## VENDOR SERVICE PUBLICATION

SUBJECT: Bendix Service Bulletin No. 629

# SERVICE BULLETIN

Inspection and replacement of certain Bendix Aircraft Magneto Brown Distributor Blocks as used on turbocharged six (6) cylinder engines.

Figure 1  
D-2000/D-3000 Series  
Batch Codes 0000 through 8552

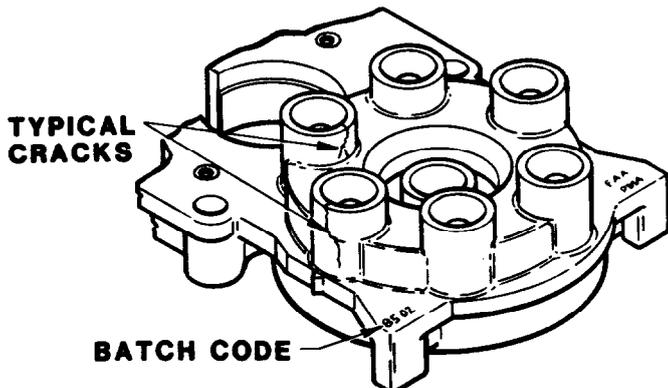
To remove from service distributor blocks that may contain outlet tower cracks. See Figures 1 through 3.

Note A: All blocks are identified with a code. The codes are molded into the outer periphery of the block and only blocks with listed codes are affected. See Figures 1 through 3.

Field reports indicate some brown distributor block towers may crack (ref. Figures 1 through 3). Should the tower or towers crack the indications could be loss of ignition to the associated spark plug(s) or possible misfiring and/or cross firing of the engine.

1. Following published procedures, remove the harness cover or adapter plate from the Magneto. Using a high intensity light, inspect each distributor block tower for open cracks as shown in Figures 1 through 3.

CAUTION: BEFORE FURTHER FLIGHT, BLOCKS FOUND WITH CRACKS MUST BE REPLACED BY BLOCKS WITH BATCH CODES NOT LISTED AS AFFECTED UNDER THE "EQUIPMENT AFFECTED" SECTION OF THIS BULLETIN. FOLLOW PUBLISHED PROCEDURES.
